City of Mississauga Department Comments

Date Finalized: 2022-11-23 File(s): A576.22

The applicant requests the Committee to approve a minor variance to allow the construction of a pool with a reduced rear yard setback to a G2 Zone of 2.219m (approx. 7.28ft) whereas By-law 0225-2007, as amended, requires a minimum rear yard setback to a G2 zone of 5.00m (approx. 16.40ft) in this instance.

Property Address: 6675 Blackheath Ridge

Appendix 1 – Transportation and Works Comments

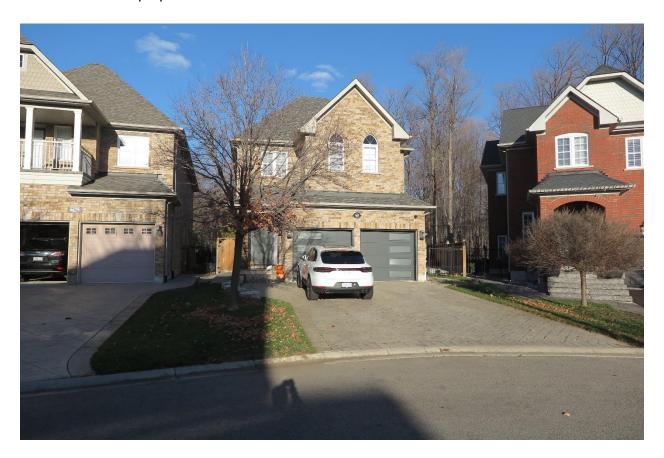
From our site inspection of the property we note that we do not foresee any drainage related concerns with the proposal.
